ATTACHMENT B-1

MARKED UP PAGES FOR
PROPOSED CHANGES TO APPENDIX A
TECHNICAL SPECIFICATIONS OF
FACILITY OPERATING LICENSES
NPF-37 AND NPF-66

BYRON STATION UNITS 1 & 2
REVISED PAGES

MARKED UP PAGES FOR
PROPOSED CHANGES TO APPENDIX A
TECHNICAL SPECIFICATIONS OF
FACILITY OPERATING LICENSES
NPF-72 AND NPF-77

FIGURE 3.4-1
DOSE EQUIVALENT I-131 REACTOR COOLANT SPECIFIC ACTIVITY
LIMIT VERSUS PERCENT OF RATED THERMAL POWER WITH THE REACTOR
COOLANT SPECIFIC ACTIVITY $> 1 \mu\text{Ci}/\text{GRAM}$ DOSE EQUIVALENT I-131*

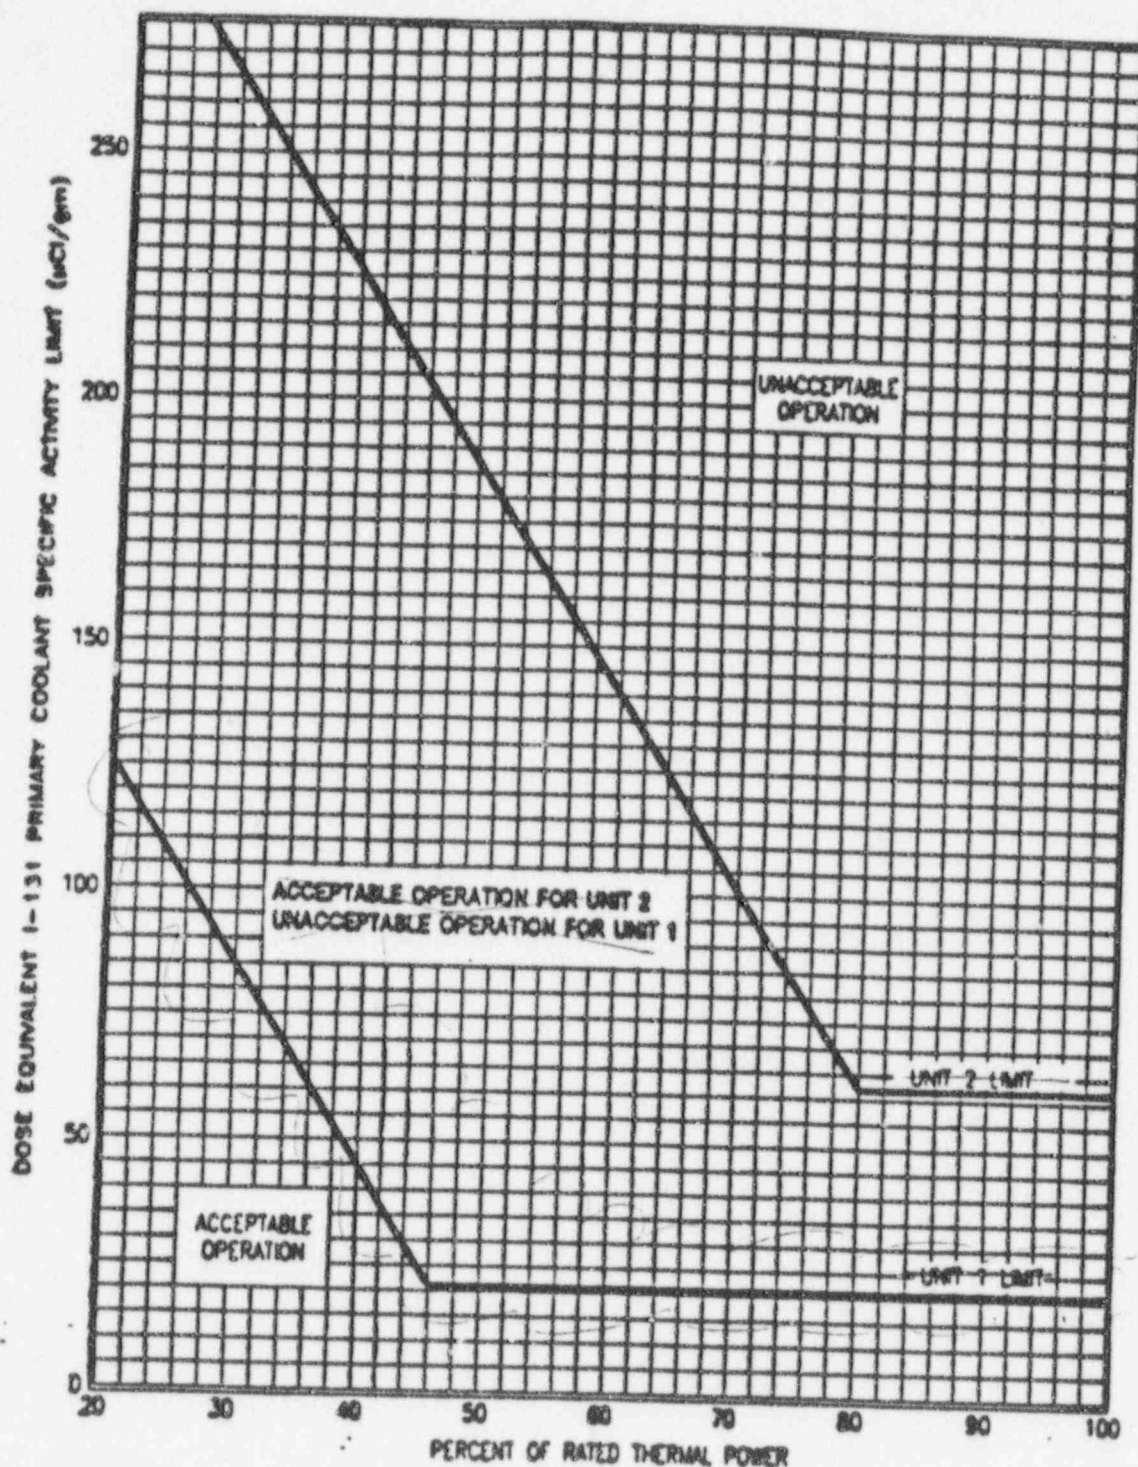
through Cycle 6

UNIT 1 (AFTER CYCLE)
AND UNIT 2

FIGURE 3.4-1²
DOSE EQUIVALENT I-131 REACTOR COOLANT SPECIFIC ACTIVITY
LIMIT VERSUS PERCENT OF RATED THERMAL POWER WITH THE REACTOR
COOLANT SPECIFIC ACTIVITY $> 0.35 \mu\text{Ci}/\text{GRAM}$ DOSE EQUIVALENT I-131*

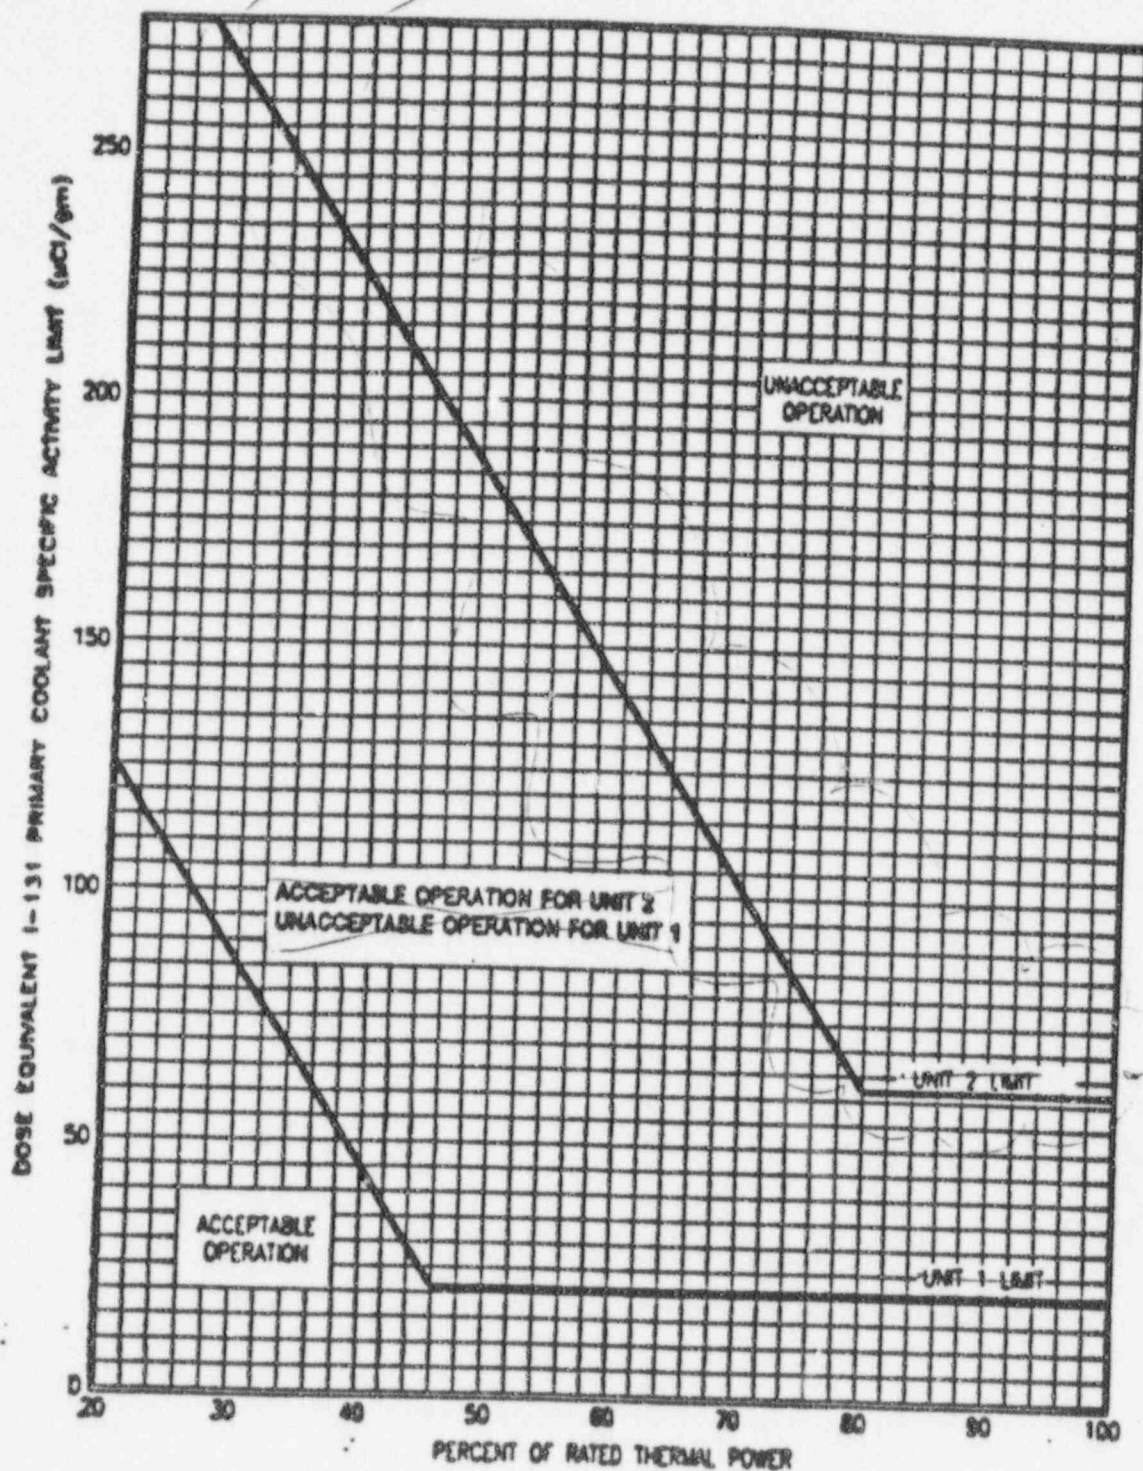
UNIT 1 THROUGH
CYCLE 8

FIGURE 3.4-1
DOSE EQUIVALENT I-131 REACTOR COOLANT SPECIFIC ACTIVITY
LIMIT VERSUS PERCENT OF RATED THERMAL POWER WITH THE REACTOR
COOLANT SPECIFIC ACTIVITY $>1\mu\text{Ci}/\text{GRAM}$ DOSE EQUIVALENT I-131*

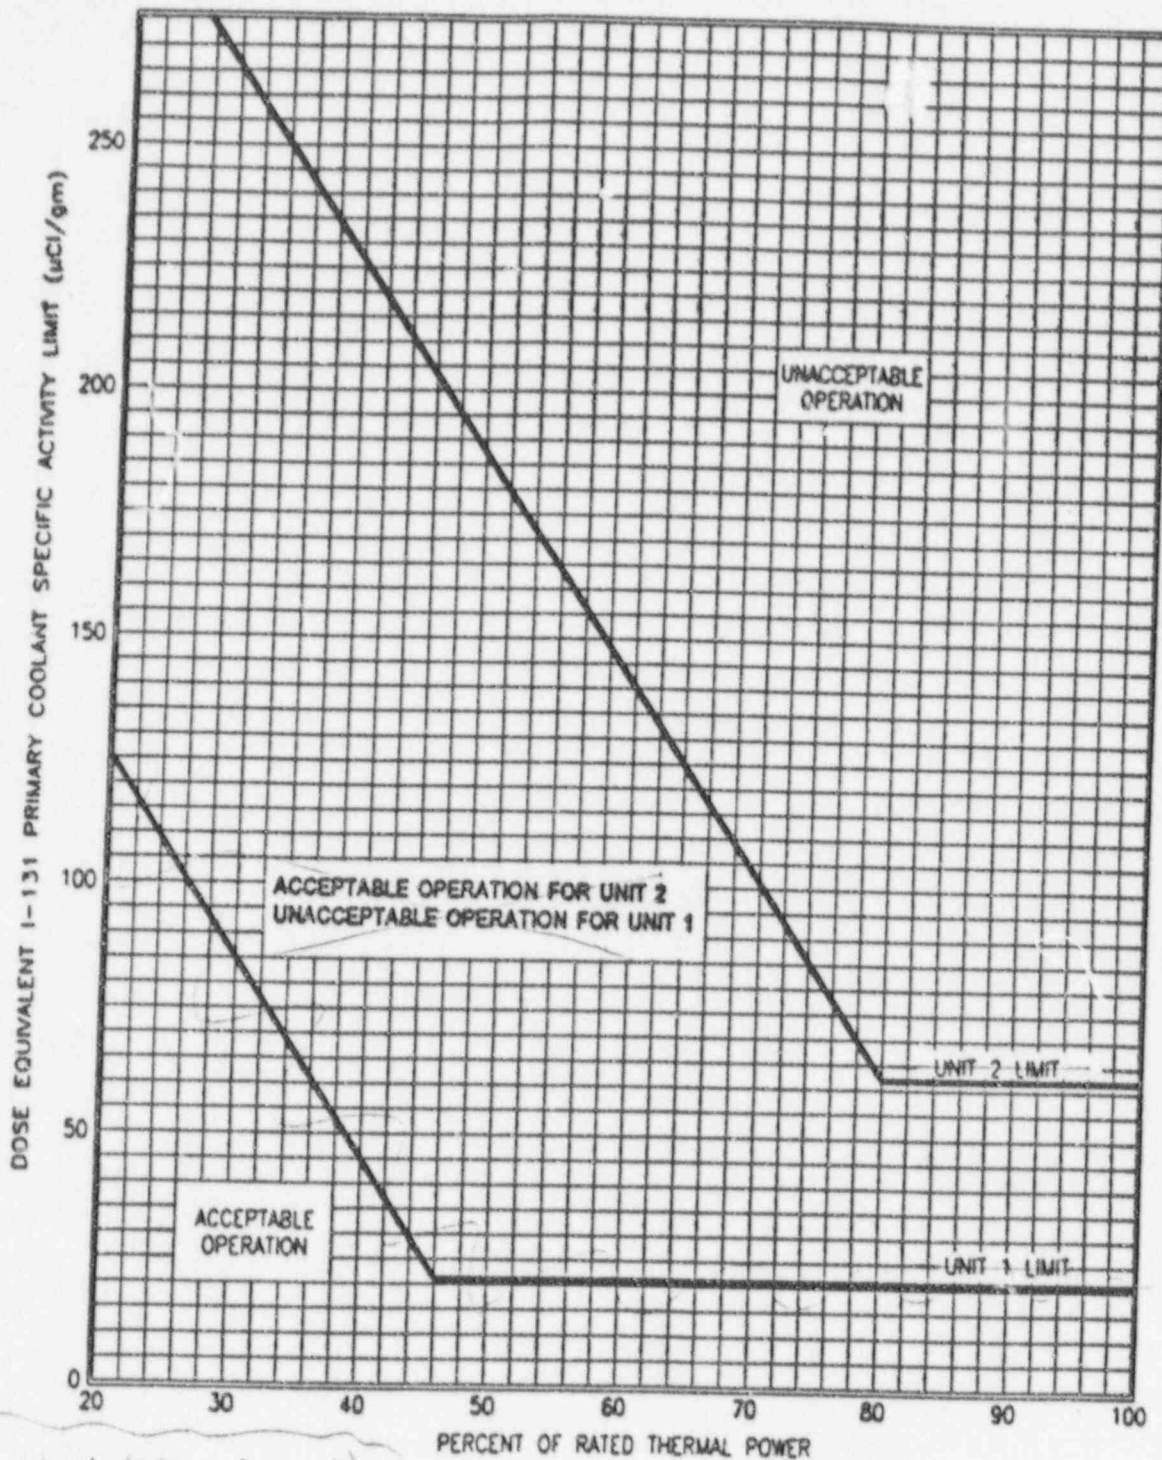
Unit 1 (After Cycle 7)
and Unit 2

FIGURE 3.4-12
DOSE EQUIVALENT I-131 REACTOR COOLANT SPECIFIC ACTIVITY
LIMIT VERSUS PERCENT OF RATED THERMAL POWER WITH THE REACTOR
COOLANT SPECIFIC ACTIVITY $> 1 \mu\text{Ci/GRAM}$ DOSE EQUIVALENT I-131*

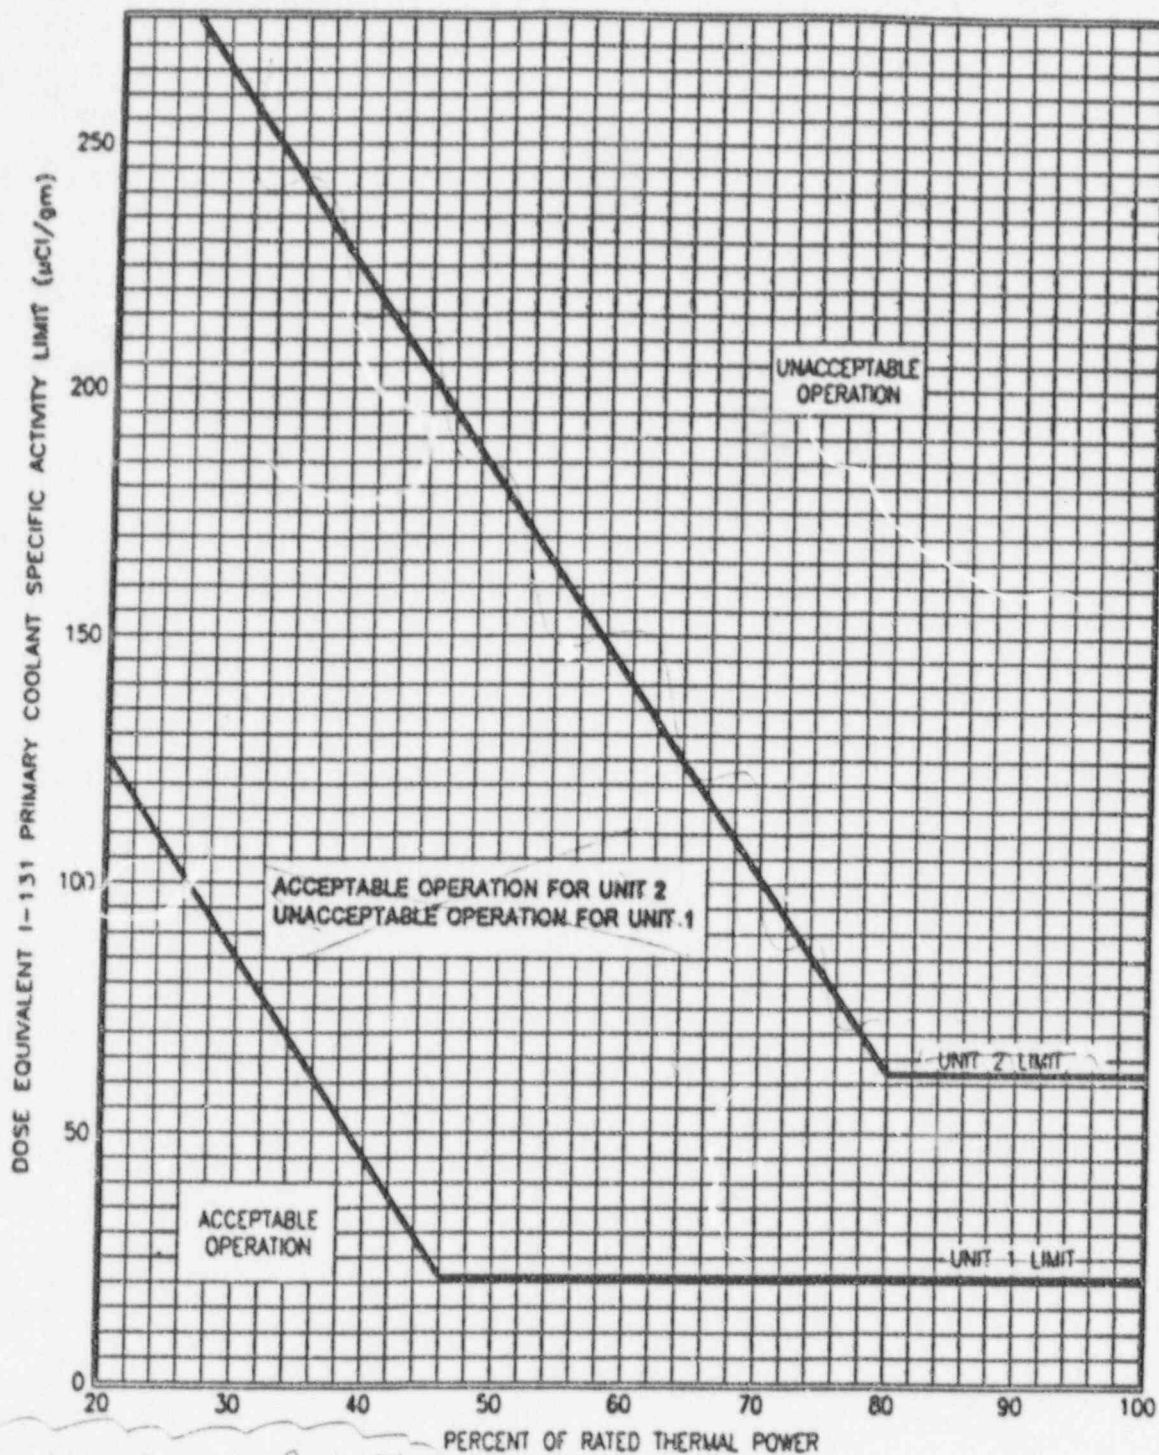
Unit 1 Through Cycle 7
